TV white spaces: approach to coexistence

Addendum

Consultation

Publication date: 24 October 2013

Figure 1. Exceedance probabilities

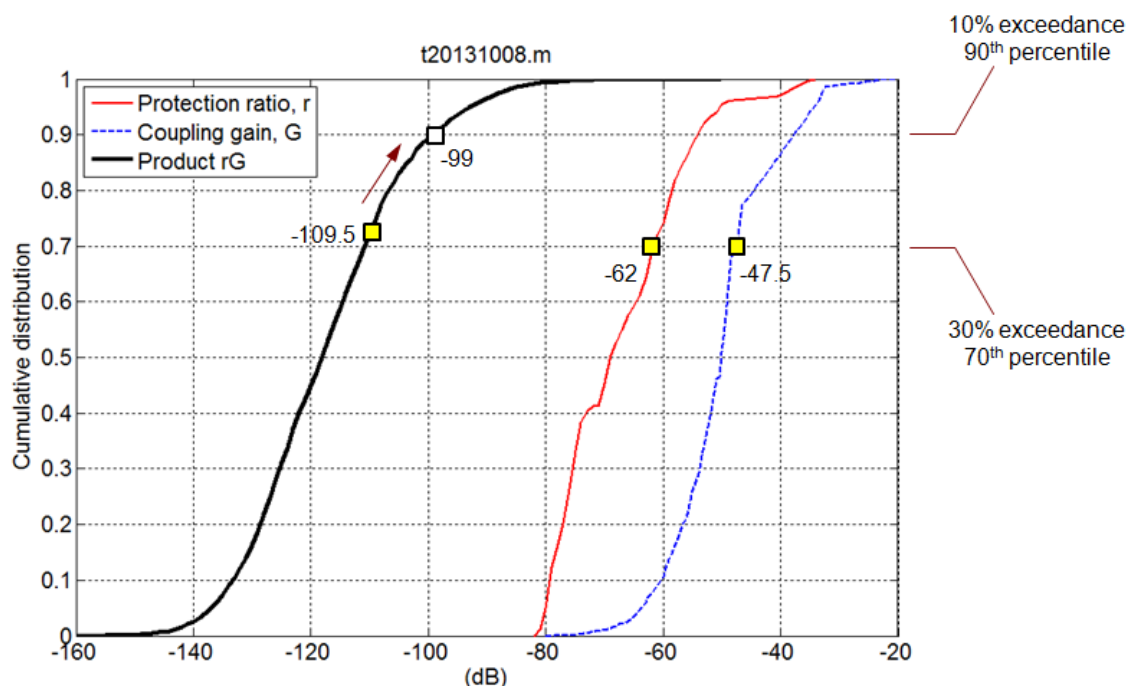
2.11 Figure 1 below provides an example for one specific interference scenario which corresponds to a frequency separation of 10 channels ($\Delta F = 10$), DTT received median wanted power of $m_S = -70$ dBm, a WSD height of 10 m, and with the WSD and DTT receiver located in the same pixel or immediately adjacent pixels. The figure shows that the use of target protection ratio (-62 dB) and coupling gain (-47.5 dB) values which are exceeded with a probability of 30% implies that the product $r_T G_T$

(and hence a 1 dB desensitisation) is exceeded with a probability of roughly 30%, and not 10% as we mistakenly thought).
